Product Change Notification

PCN-017_2023_1-OMTB2309301

Laser marking correction on products

ATO series – **First date code**

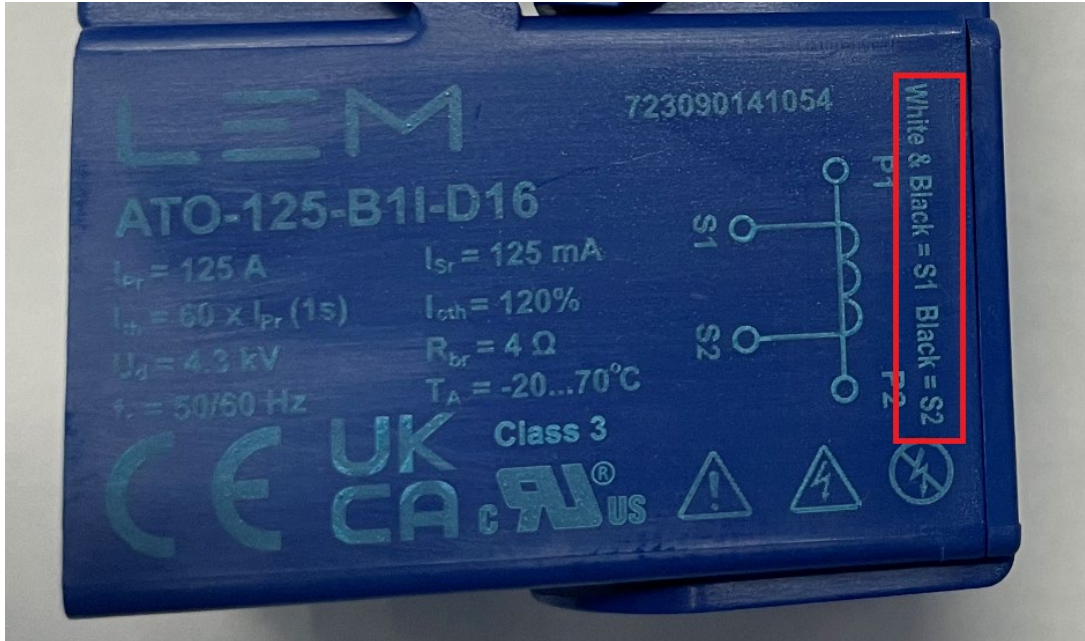
Marking information correction for the output cables S1 & S2 for their function signification.

Currently this is marked on the case of the products that the S1 output cable is black when in fact this is a wire of both colors (black and white).

Currently this is marked on the case of the products that the S2 output cable is white when in fact this is a black wire.

So we correct the current marking on the case of the products to make it matching with the reality and the original information provided in the products data sheets.

D16 models, marking after: Output cable marking in red area:

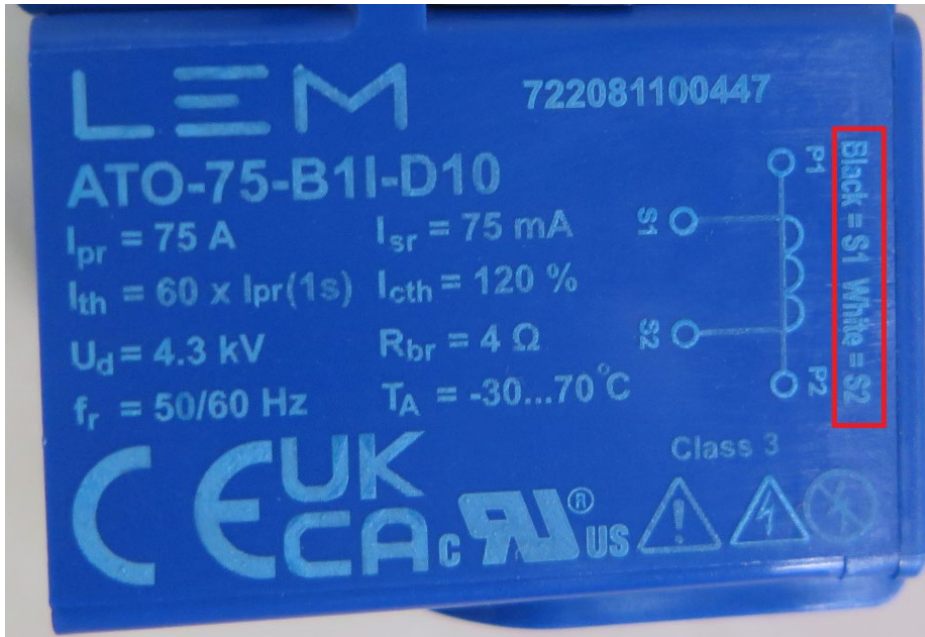
Just change of the wires color signification on the products cases (laser marking) as illustrated here after:

D16 models, marking before: Output cable marking in red area:
